Request for Review

Please find below the response to the review formulated for the CDM project with the registration number 2007. In case you have any further inquiries please let us know how we can kindly assist you.

Response to the CDM Executive Board

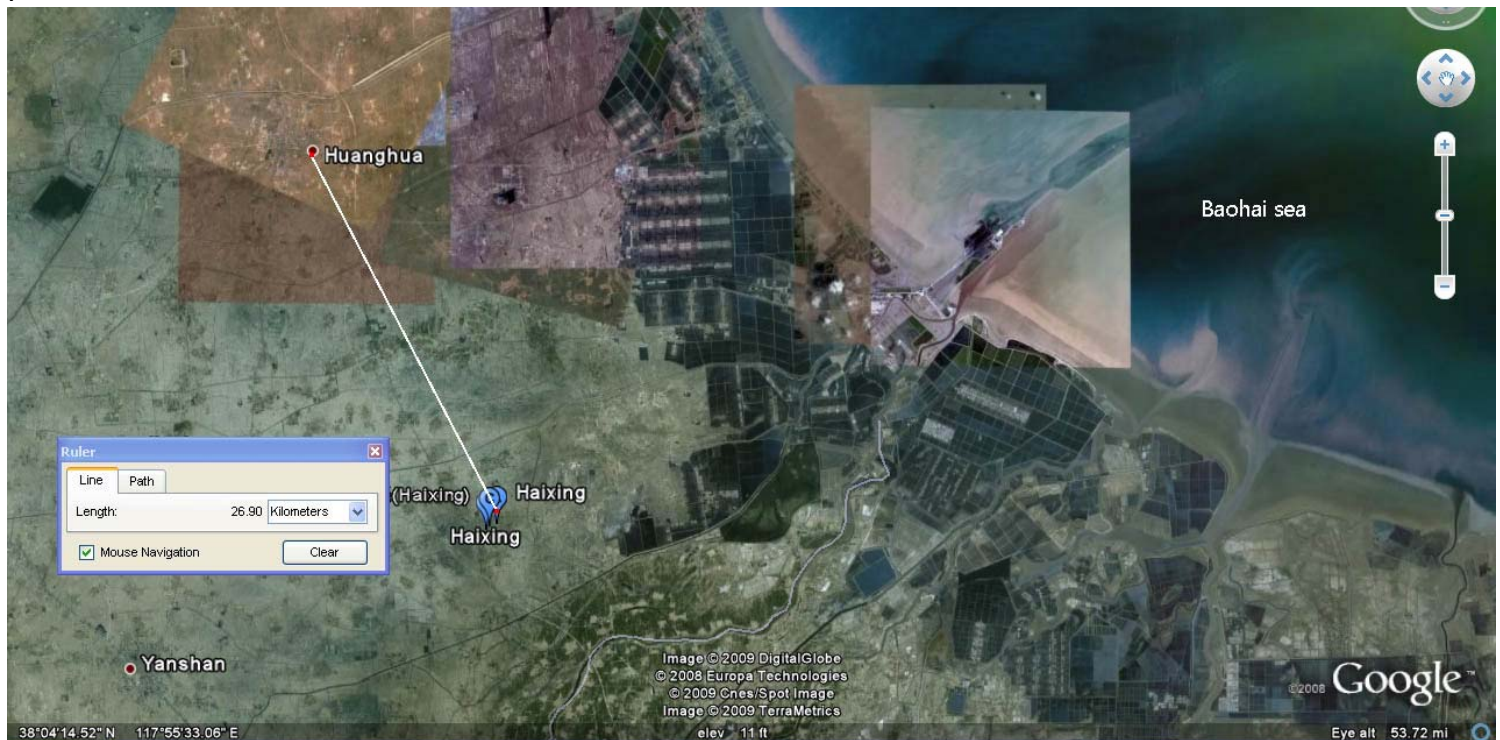
The operational hours of Haixing project is estimated to be 2323 hours per year. This value is mainly influenced by the turbine availability, grid availability and the wind speed. For the Haixing project, it is assumed in the PDD and FSR that the turbine availability and grid availability is maximized. So, the main factor to determine the output is the wind speed. The wind speed used in the FSR is sourced from the on-site wind data measurements from March of 2005 to March of 2006 and with reference of the historical wind speeds between 1971 and 2005 measured by Haixing Meteorological Station.

The calculations for the Haixing project are carried out using professional WASP software (www.wasp.dk) designed for wind energy, which is used by wind developers and turbines manufacturers worldwide.
